# V.150.1

**Corrigendum 1**

**Corrigendum to Recommendation V.150.1 - Procedures for the end-to-end connection of V-series DCEs over an IP network**

*This corrigendum to V.150.1 adds clarification to terms used in V.150.1, corrects an error in one of the SDL diagrams, defines the scope of SSE Reason Identifier Codes, clarifies the use of the SSE p-prime signal and makes some corrections to the SDP as described in Annex E.*

Figure 1/V.150.1 - SDL for State (a,a) part 2

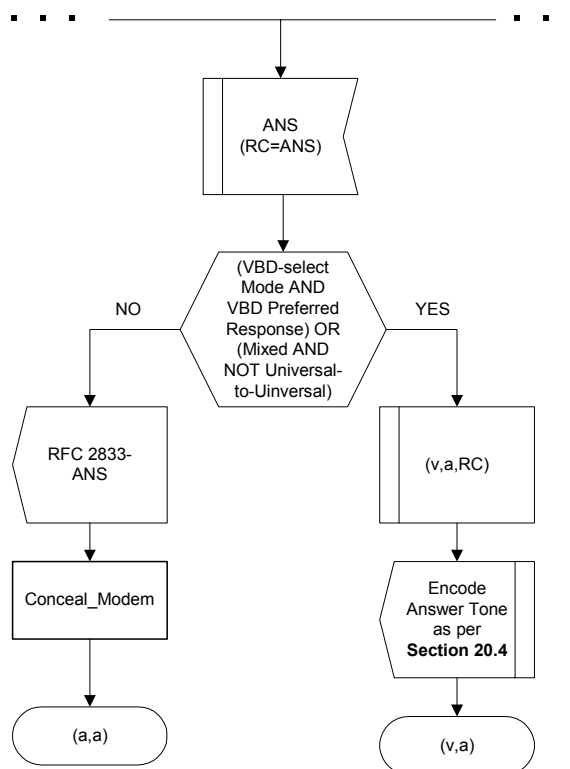
- 2) Figure 27/V.150.1 is to be replaced with the following version. This corrects the use of an incorrect SDL primitive.
